01/26/2026

**ADDENDUM NO. 3  
TO CONTRACT DOCUMENT PLANS SPECIFICATIONS**

**PROJECT: MWA METRO PARK WEST LANDFILL  
P-67 CELL E LINER, LEACHATE LAGOON, AND SED POND**  
**TO: PROSPECTIVE BIDDERS AND OTHER INTERESTED PARTIES**

SHEET  
C101

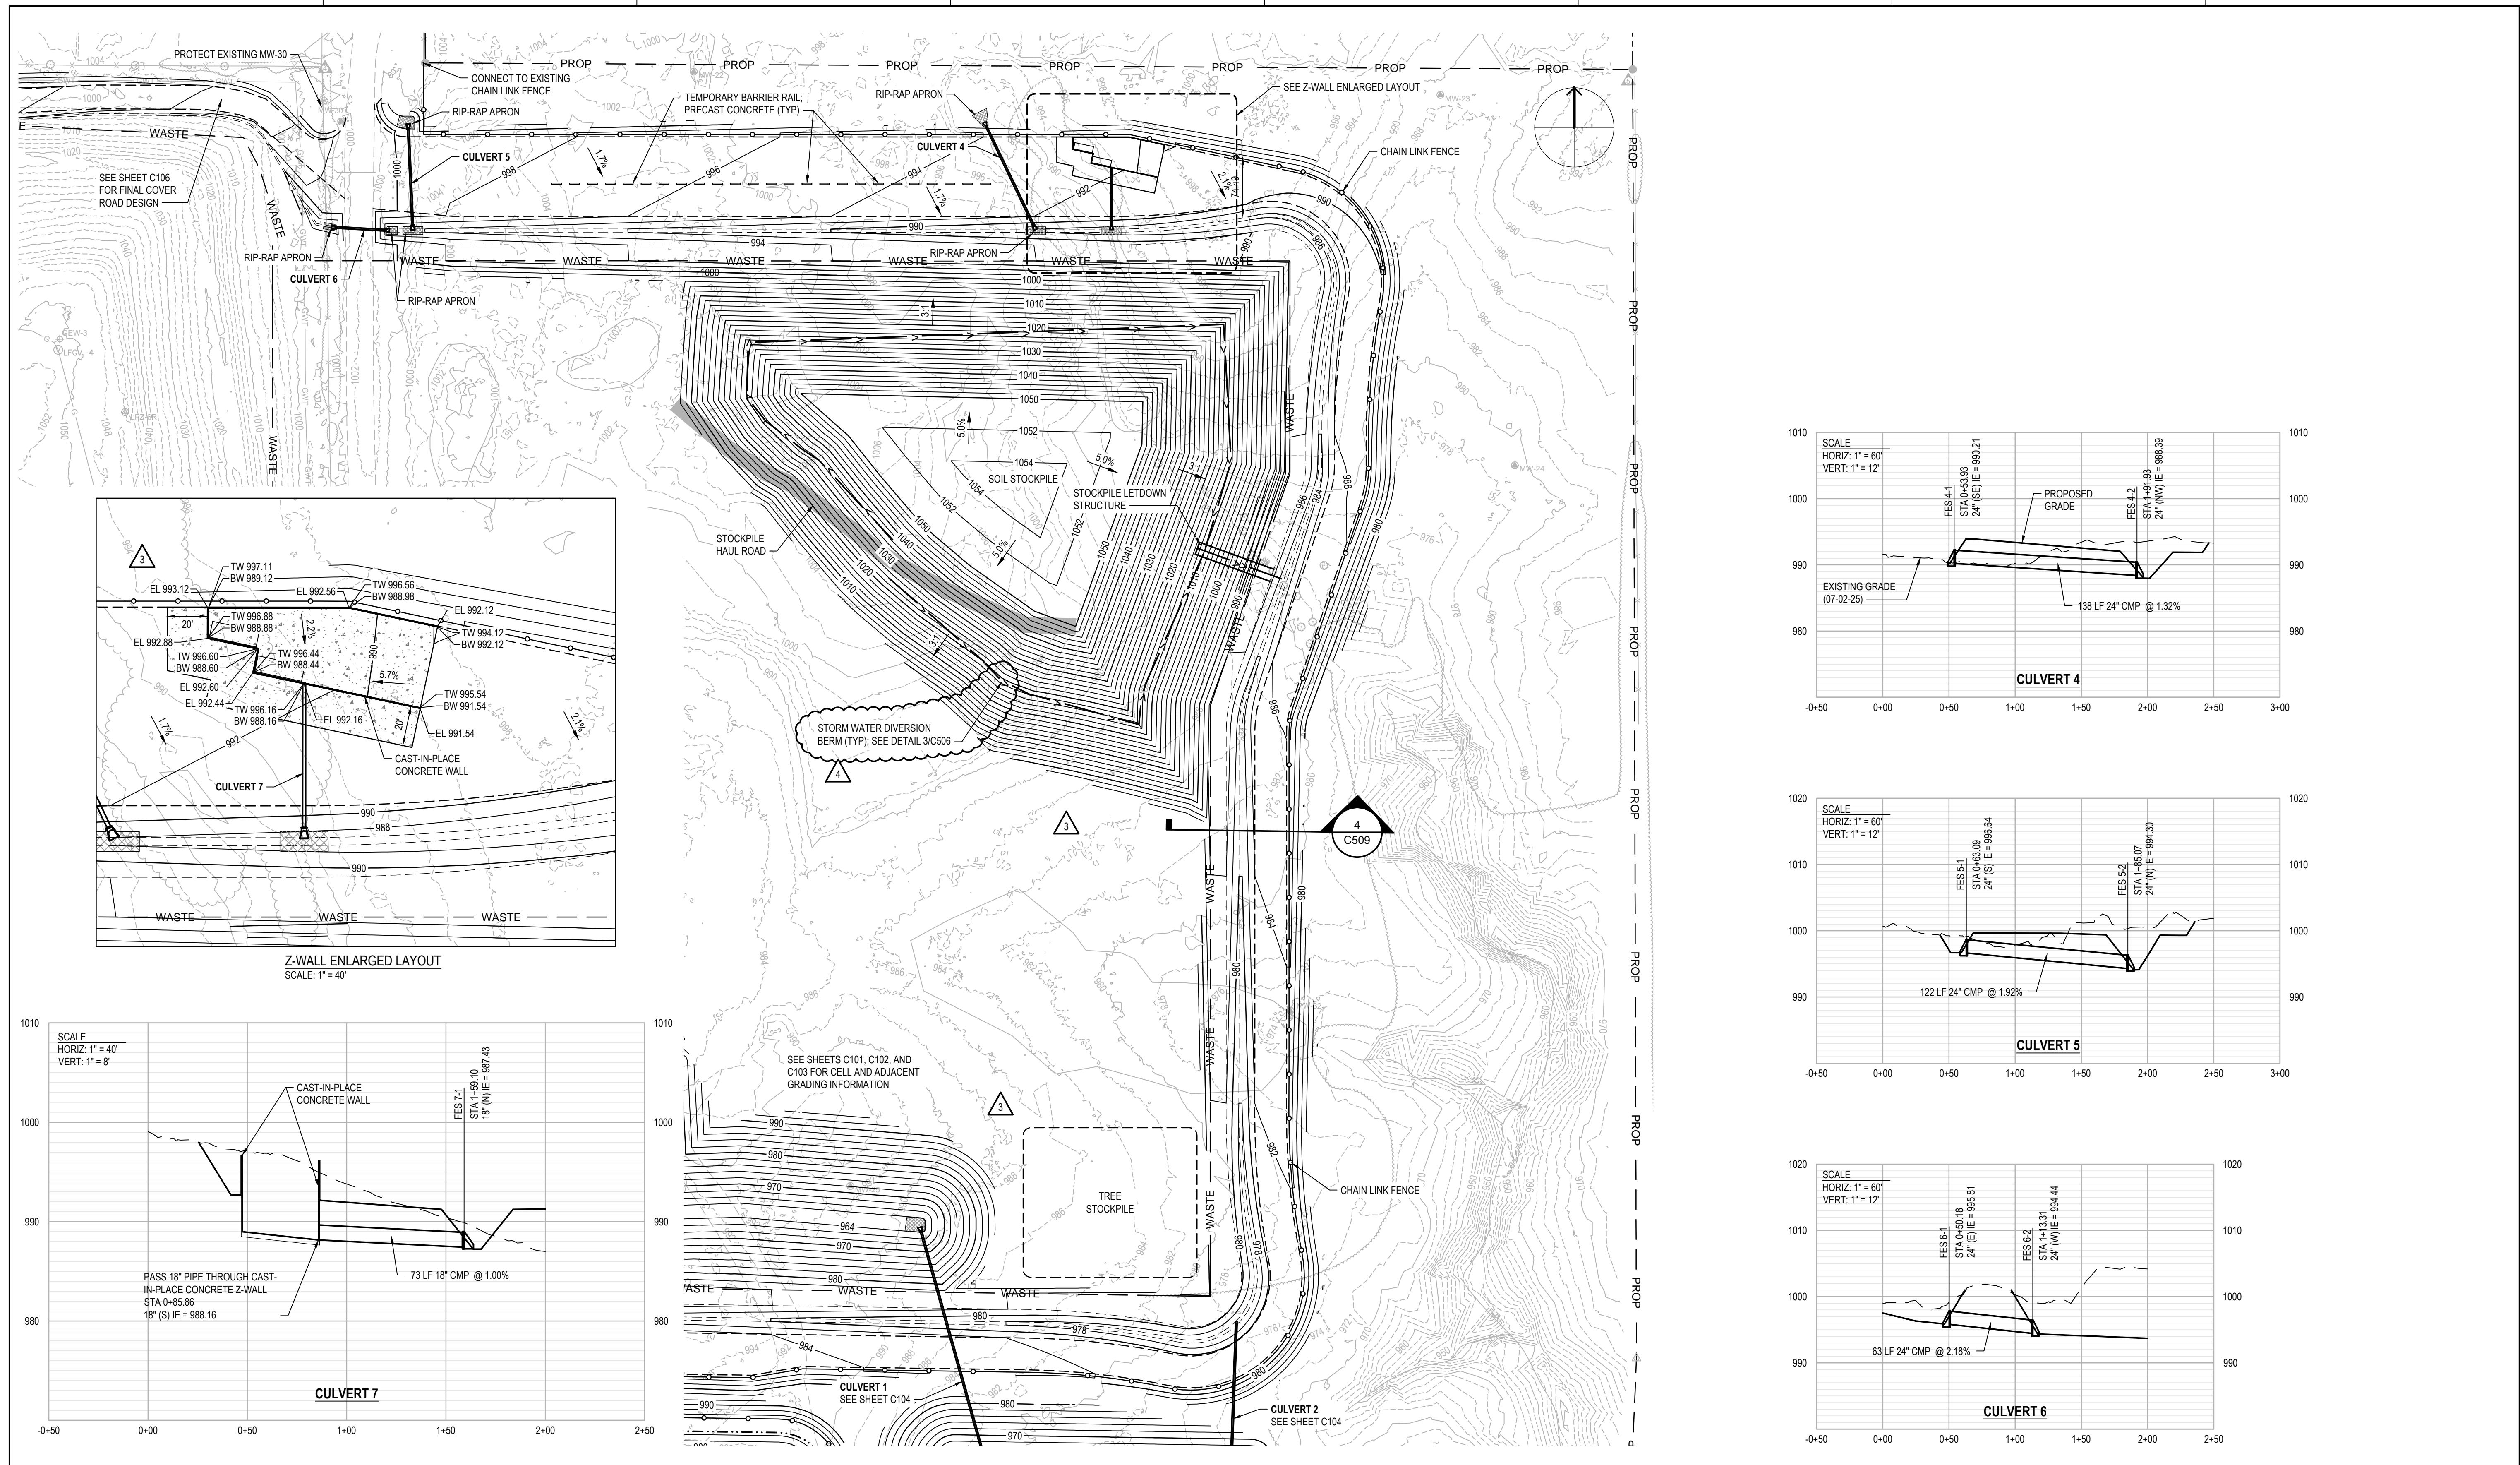
**Question 10:** *Bid item 113 and 114 both show to include Leachate Control System with pump and loadout as well as seepage drain. Please clarify. Bid item 113 states to include 1000 LF of seepage drain. C101 shows approximately 1500 LF. How much should be included and in which item?*

**Question 12:** *Please provide details on the groundwater cleanout riser.*

**Question 19:** Question 14 had asked for the elevations for the ground water control trench per the detail on sheet C506. The answer said to see revised detail, but we need the invert elevations for the pipe. The east - west GWT lateral passes beneath the leachate sump risers and that is a low point, meaning the GWT at the SW corner of the cell has to be deeper than the 6' called out for in the plans or the East-West Lateral won't drain properly. Can you please take a look at that and get back to us.

**Answer 12:** Groundwater cleanout riser is a solid wall 8" PVC (Sch 80) with air tight threaded PVC screw on cap that is terminated a minimum 2' above ground surface at the location identified on Sheet C101.

**Answer 19:** See revised Sheet C101 issued with Addendum #3 for Groundwater Trench Header Elevations.
